PETITION NO: Z-5

PROPOSED ZONING: OI

PROPOSED USE: Office

Z-5

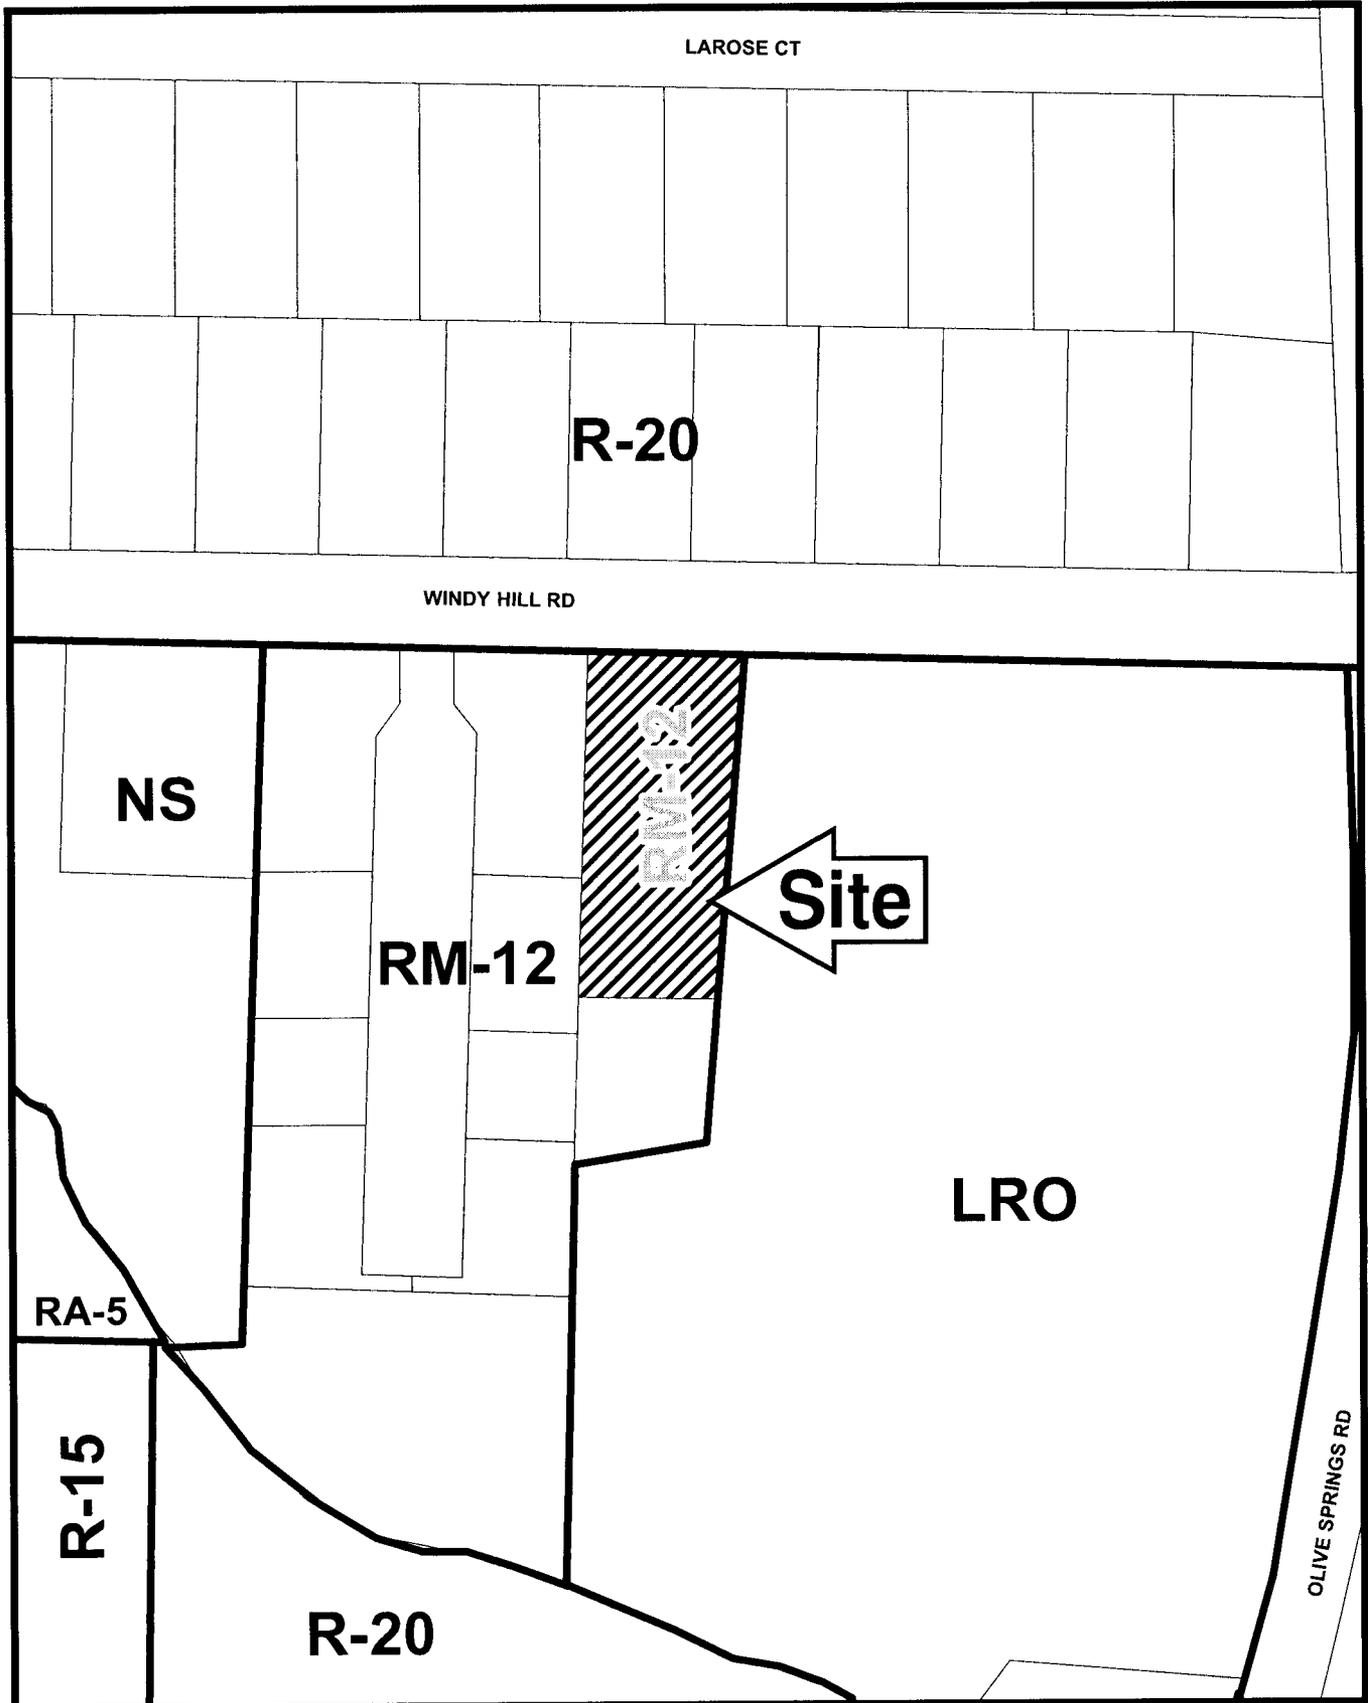
The applicant is showing a contemporaneous variance which is to reduce the side setback adjacent to the east property line from 15-feet to 10-feet.

1. The existing site discharges to the west through the adjacent Piedmont Villas Apartments. There is not adequate stormwater conveyance to accommodate a concentrated discharge from the proposed site through this older apartment complex. The proposed underground detention system must be designed to discharge directly to the existing stormwater system located within the Windy Hill Road R/W.
2. Since a portion of the adjacent St. Jude Episcopal Church property drains through the proposed site, this runoff must be accommodated in the site stormwater design and adequate conveyance provided through the site.

Windy Hill Road is classified as an Arterial and according to the available information, the existing right-of-way does not meet the minimum requirements for this classification.

Recommend applicant consider entering into a development agreement pursuant of O.C.G.A. 36-71-13 for dedication of the following system improvements to mitigate traffic concerns: a) donation of right-of-way on the south side of Windy Hill Road, a minimum of 50' from the roadway centerline.

Based on the above analysis, Staff recommends DELETION to LRO subject to the following conditions:

- Site plan received by the Zoning Division December 6, 2007, with the District Commissioner approving minor modifications;
- Fire Department comments;
- Water and Sewer comments and recommendations;
- Stormwater Management comments and recommendations;
- DOT comments and recommendations; and
- owner/developer to enter into a Development Agreement pursuant to O.C.G.A. §36-71-13 for dedication of system improvements to mitigate traffic concerns.
